RS-15-137

Clinton Power Station, Unit 1
Facility Operating License No. NPF-62
NRC Docket No. 50-461

Subject: Report of Full Compliance with March 12, 2012 Commission Order Modifying Licenses with Regard to Reliable Spent Fuel Pool Instrumentation (Order Number EA-12-051)

CPS Revised Sketch #1 (one page)
Transmitter and Electronic Enclosure Layout

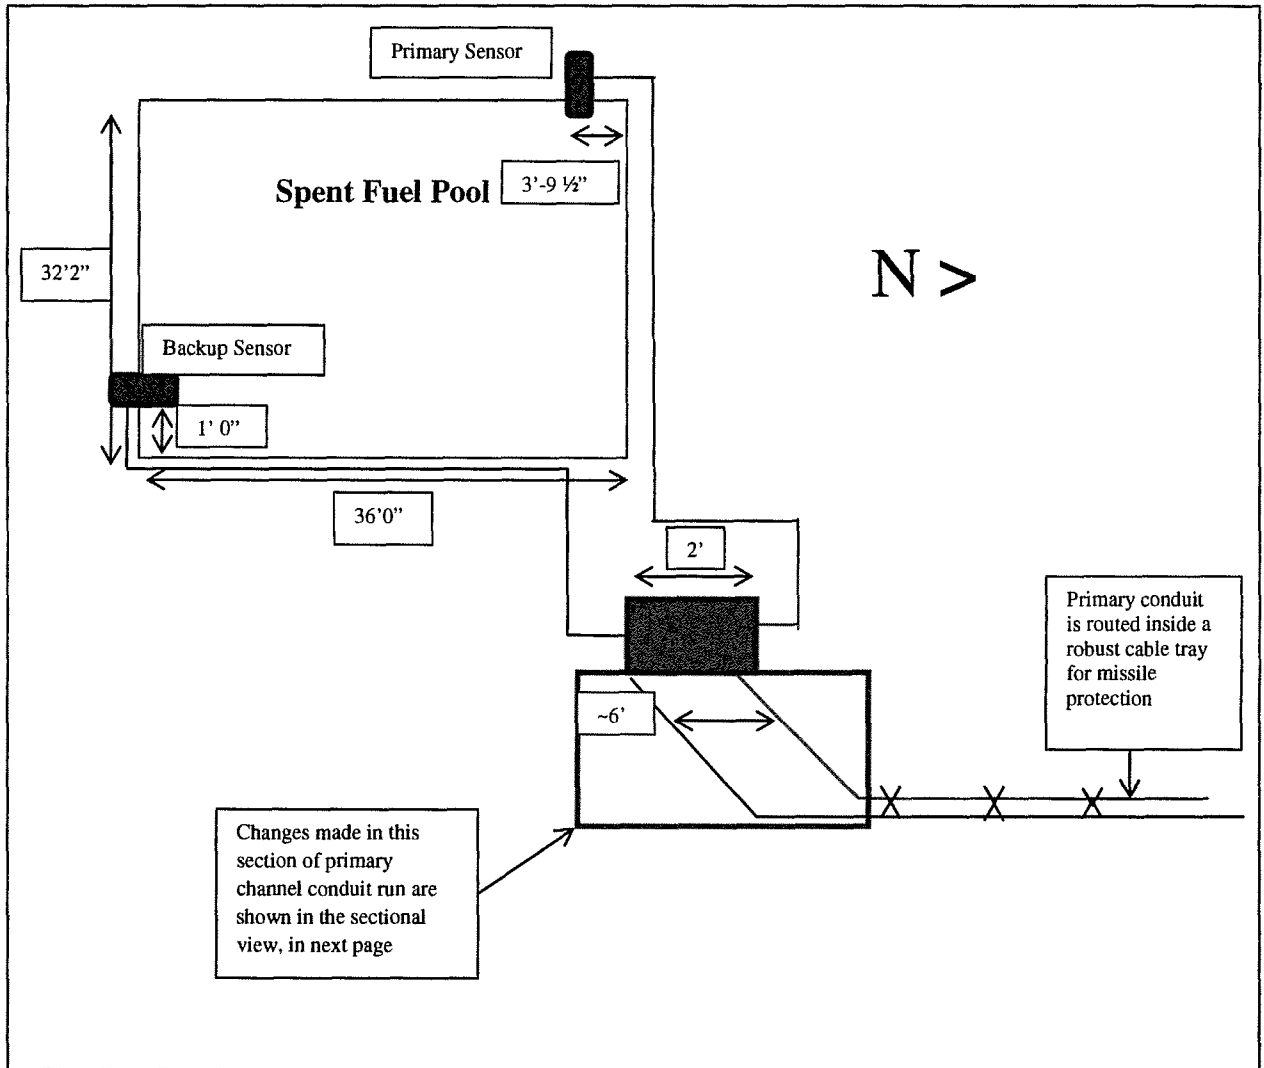
Item	Description	Reference
OIP Item 5 (RAI- 5, Ref. 3) OIP Item 2 (RAI- 2, Ref. 3) b) Further information on the use of physical and spatial separation	<p>The following is a summary of the additional actions taken to provide as much physical and spatial separation within the Spent Fuel Building area utilizing, to the maximum extent practical, inherent shielding from missiles provided by existing recesses and corners in the Spent Fuel Building structure at Clinton Power Station (CPS) (Reference enclosed Sketch #2).</p> <p>Spent Fuel Probes: The two spent fuel probes were moved at opposite corners of the Spent Fuel Pool, one on the NE corner and the other on the SE</p>	Complete

<p>corner of the pool, to obtain the maximum extent practical separation. The original design had a separation of approximately 34 feet, and the final installed configuration has a separation of 45 feet, which meets the NEI 12-02 requirement of separating the sensors at least by the shortest distance of the pool edge (i.e., 32 feet).</p> <p>Probe Coax Cable Signal Routing: Where the channels leave the spent fuel area, a change was made so the signal cable is routed in conduit on opposite faces of a two (2) foot wide webbed column, which is part of the support for the Fuel Building, a seismically designed and constructed structure. The channel cables are then routed, after leaving the top of the column, with one conduit (primary) being four (4) feet higher than the other to provide practically achievable separation due to interferences at the top of the column. After approximately eighteen (18) inches, the conduits maintain a separation of six (6) feet for a distance of approximately 10 feet into a separate conduit and a cable tray. At the cable tray, the primary channel is routed in a robust cable tray, and the secondary channel is routed in its own conduit outside the cable tray. The cable tray provides reasonable protection to the primary channel. Both channels are supported by seismically installed support hangers. The cable tray and conduit remain common to the tray supports until approximately ten (10) feet from the North Fuel Building wall, where they then separate, one in the tray and the other in a conduit by a distance of approximately five (5) feet until penetrating the North Fuel Building wall.</p> <p>Structural calculations IP-S-0303 and IP-S-0311 were revised, as required, to address the structural adequacy of conduit supports due to additional separation being provided from the column to the cable tray in the Fuel Building.</p> <p>The above described changes further enhance the design for the SFPI at Clinton Power Station and meet the NEI 12-02 requirements.</p>
